# Executive Director's Recommendation

<b>PROJECT</b> <b>Joint Base Andrews Consolidated Communications Center</b> Joint Base Andrews Camp Springs, Maryland	<b>NCPC FILE NUMBER</b> 7902
	<b>NCPC MAP FILE NUMBER</b> 3207.00(38.00)44911
<b>SUBMITTED BY</b> United States Department of Defense Department of the Navy	<b>APPLICANT'S REQUEST</b> Approval of final site and building plans
<b>REVIEW AUTHORITY</b> Federal Projects in the Environs per 40 U.S.C. § 8722(b)(1)	<b>PROPOSED ACTION</b> Approve of final site and building plans with comments
	<b>ACTION ITEM TYPE</b> Consent Calendar

# Joint Base Andrews New Consolidated Communications Center (P-3003)

Approval of Final Site and Building Plans

# Impervious Surface Area Change

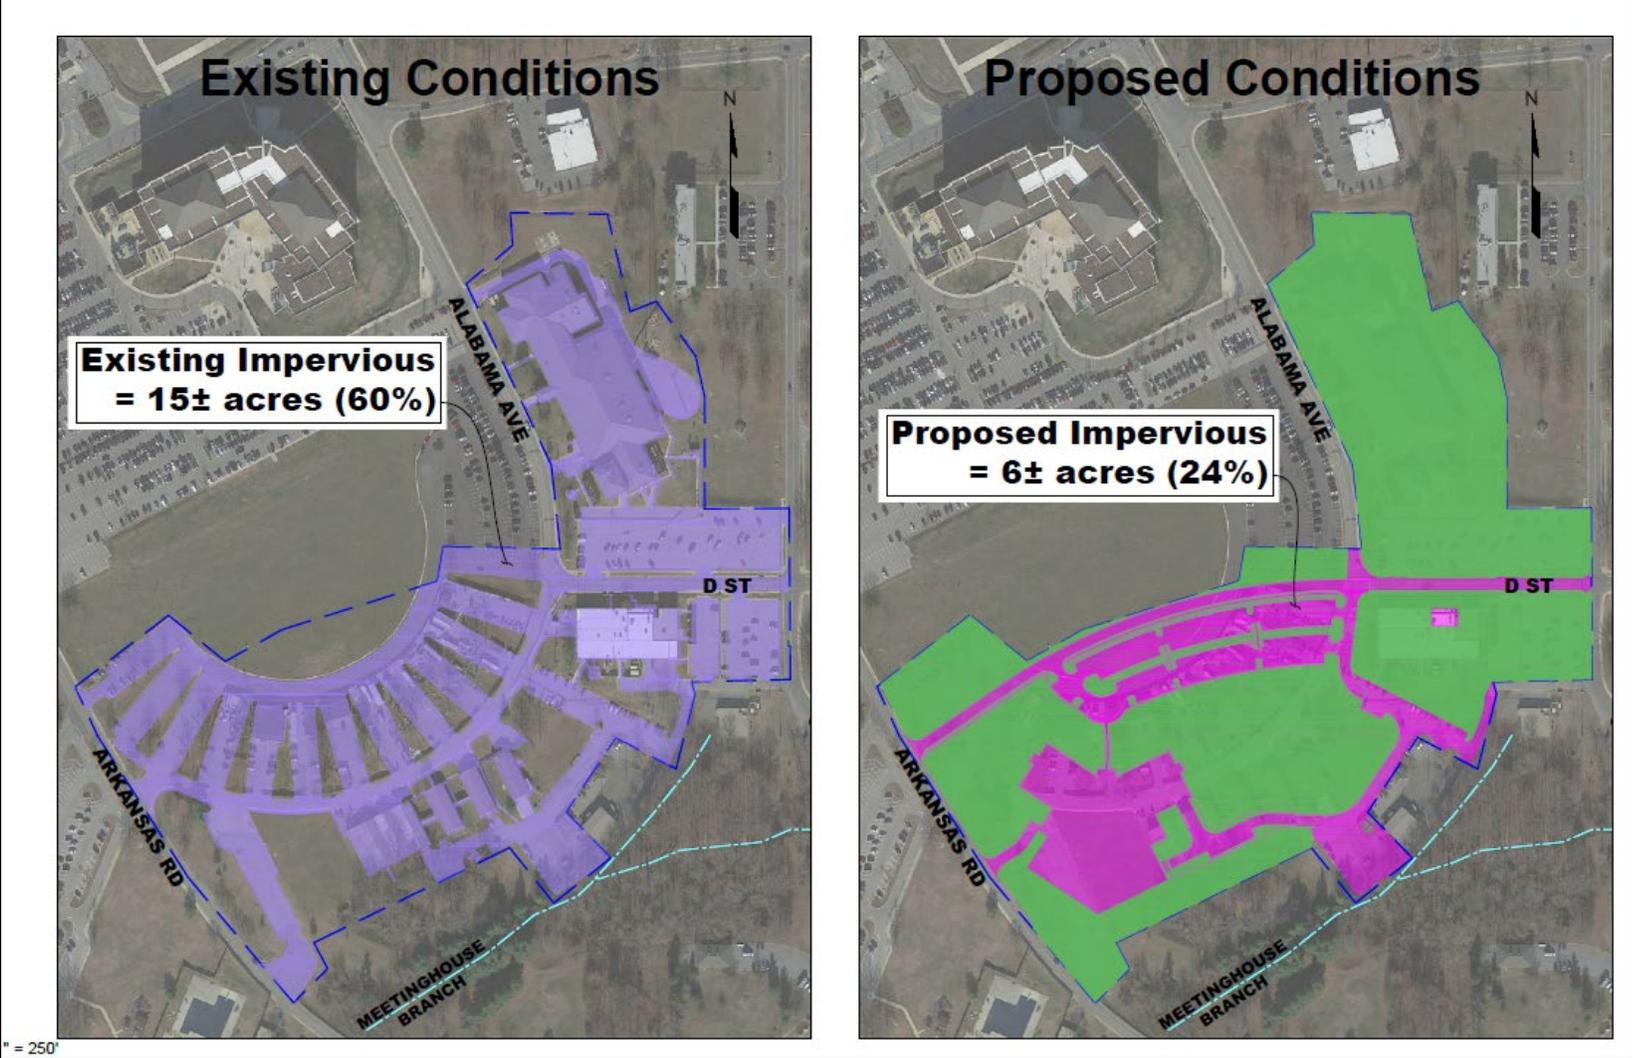
**Notes** that the Navy has demonstrated compliance with applicable stormwater management requirements as previously requested by the Commission during its review of the preliminary design.

The preliminary submission states that the new CCC will significantly reduce impervious area within the project's limit of disturbance and comply with applicable State and federal stormwater requirements under Section 438 of the Energy Independence and Security Act (EISA). NCPC's preliminary review action requested performance information that demonstrates compliance with applicable requirements and in response, the Navy has submitted a State-approved stormwater management plan. The plan states that the project's stormwater requirements are being satisfied through a 7.7-acre reduction in impervious area, which includes a 1.83-acre credit applied to the Water Quality Bank for Piscataway Creek. Based on the information submitted, staff is satisfied that the project will adhere to applicable stormwater requirements. Therefore, staff recommends that the Commission **note that the Navy has demonstrated compliance with applicable stormwater management requirements as previously requested by the Commission during its review of the preliminary design.**

# Notable Project Features

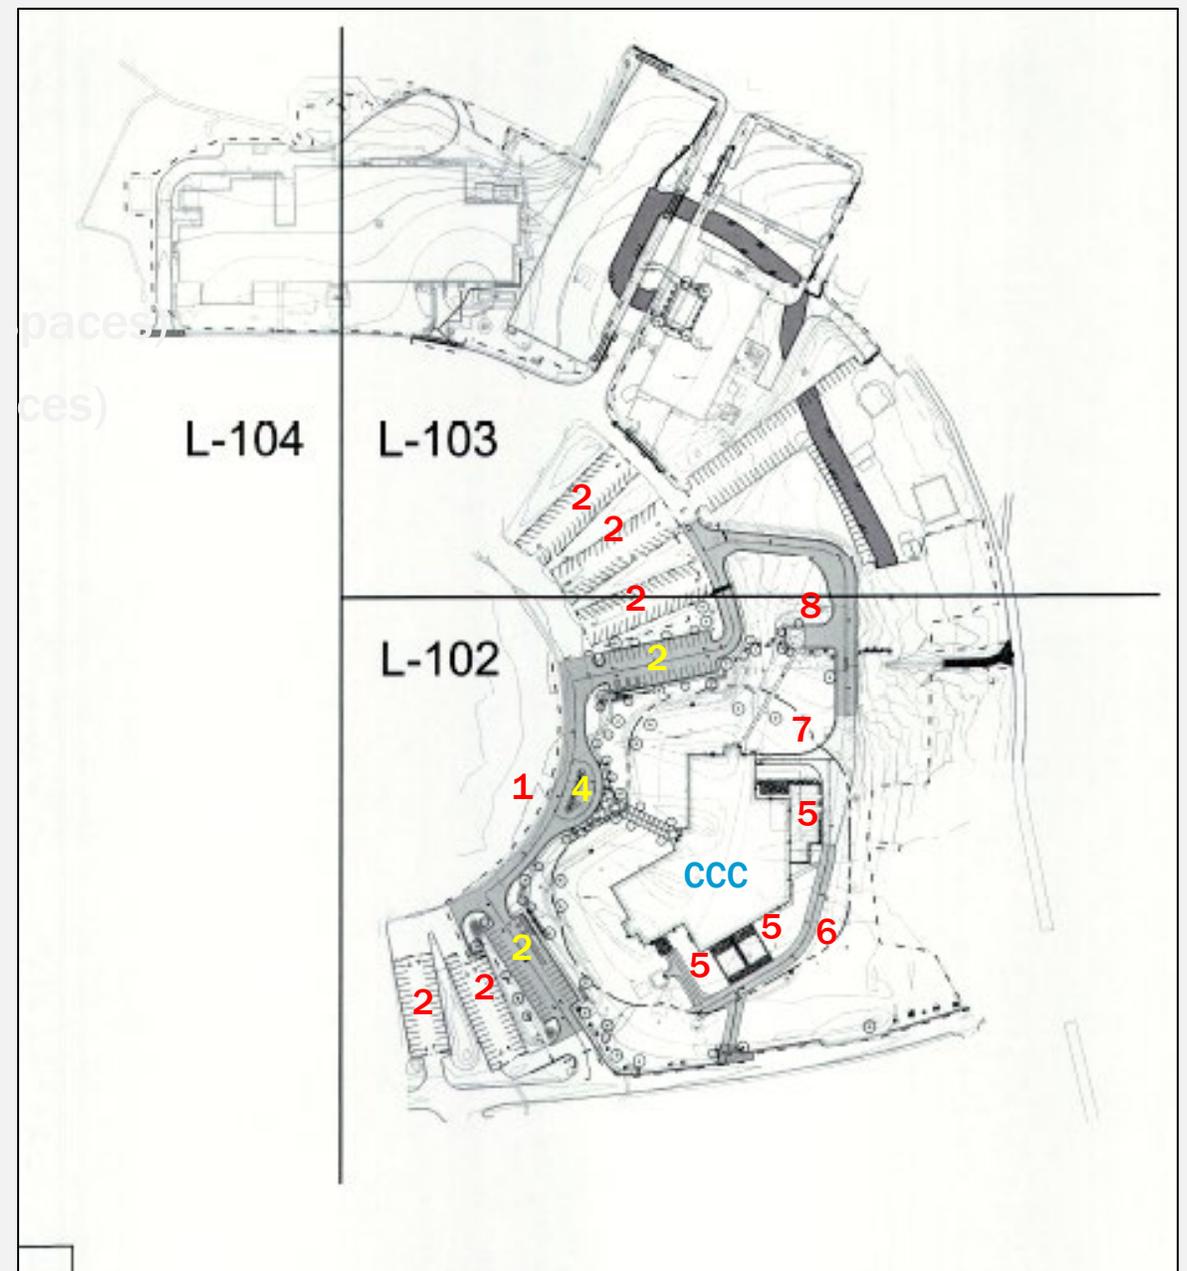
**Notes** that plans show potential future expansion areas for the building. Any proposed expansions will require review by NCPC.

# Landscape Plan

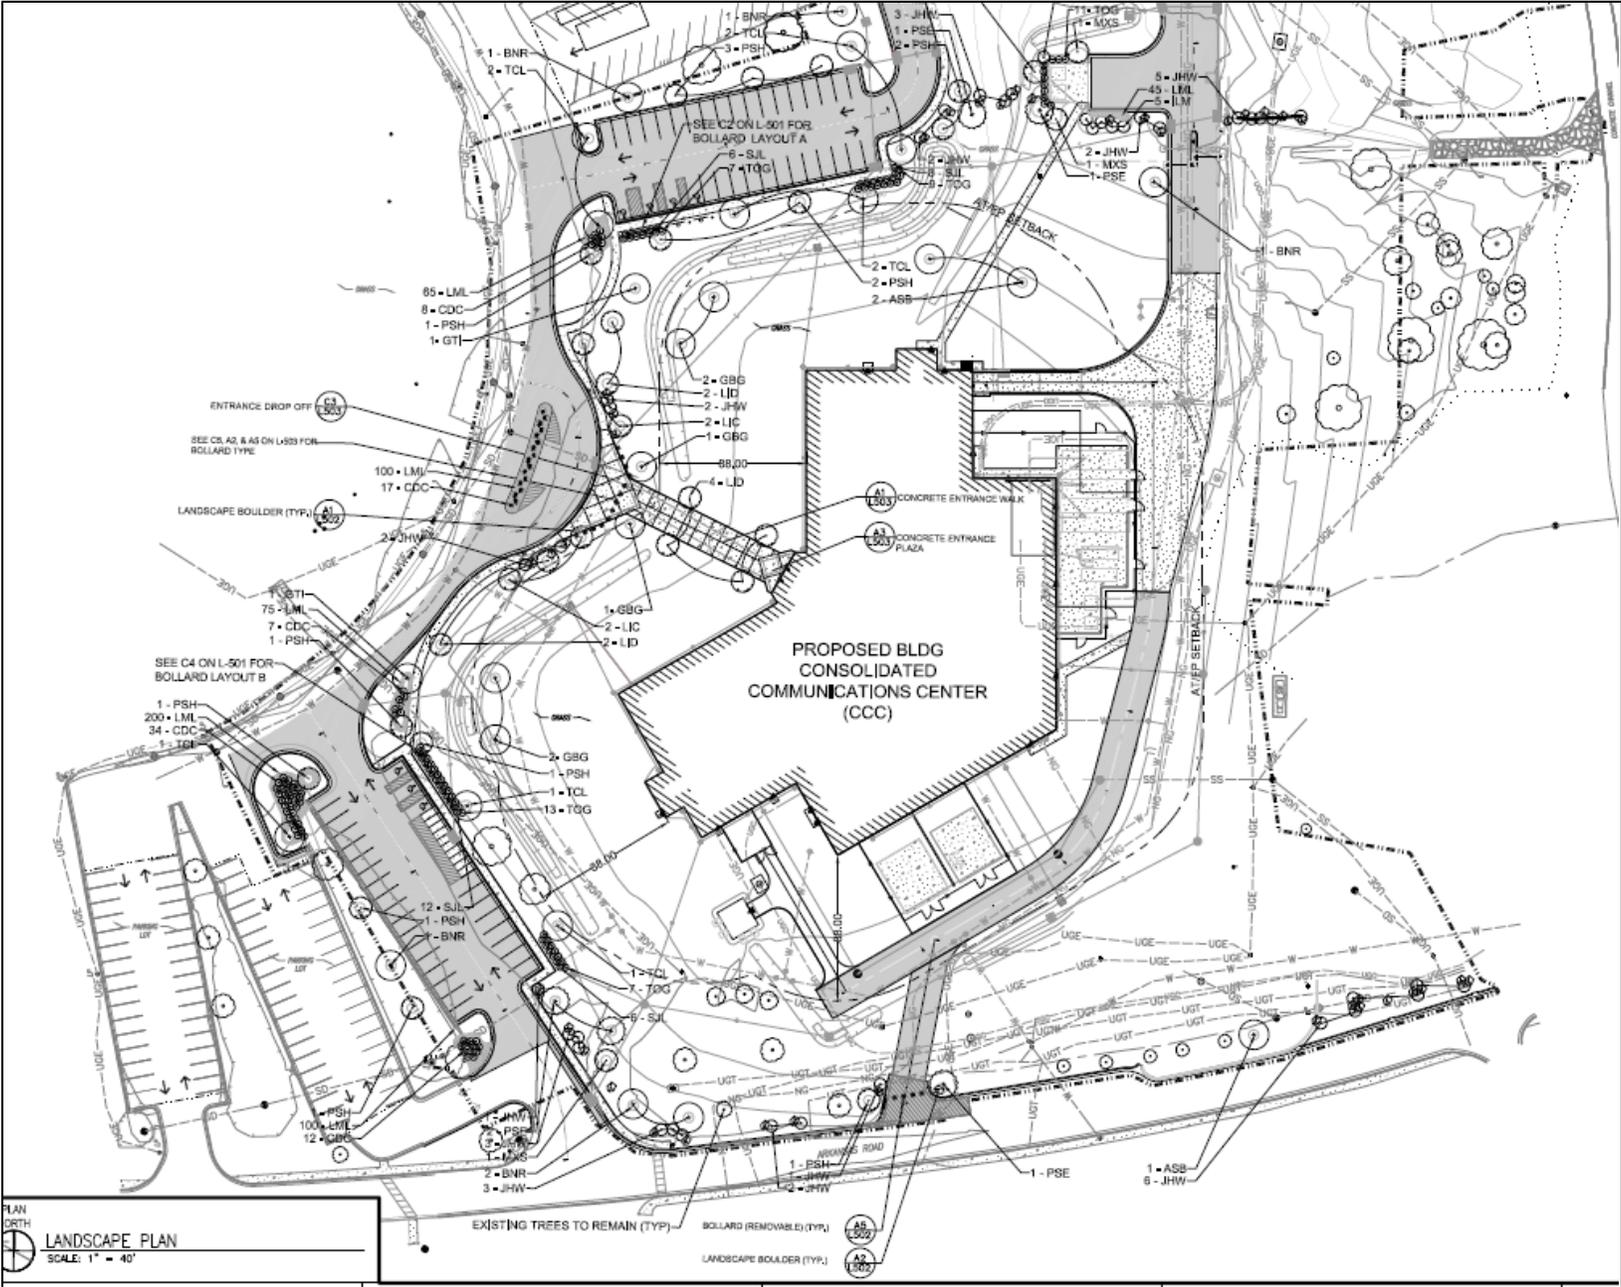
**Notes** that the Navy has submitted final landscape plans that reflect a one-to-one tree replacement ratio, which is consistent with the Comprehensive Plan (Policy FE.G.2), previously requested by the Commission during its preliminary design review. The project will also replace trees consistent with the Joint Base Andrews Arbor Plan policy that requires canopy area at a minimum of 60% of the total removed tree canopy area.

The preliminary submission states that tree removal will be mitigated at a one-to-one ratio, which is consistent with NCPC's tree policy (FE.G.2.) The final design shows removal of 34 existing on-site trees, with 35 replacement trees planted on the grounds of the new CCC as reflected in the final landscape plan. In addition, the project will adhere to Joint Base Andrews's replacement policy (2011 Arbor Plan), which requires total canopy area of the new trees to exceed 60% of the total tree canopy area of trees removed for projects greater than one acre. The final submission demonstrates that the project will adhere to the Air Force standard. Therefore, staff recommends that the Commission **note that the Navy has submitted final landscape plans that reflect a one-to-one tree replacement ratio, which is consistent with the Comprehensive Plan (Policy FE.G.2), previously requested by the Commission during its preliminary design review. The project will also replace trees consistent with the Joint Base Andrews Arbor Plan policy that requires canopy area at a minimum of 60% of the total removed tree canopy area.**
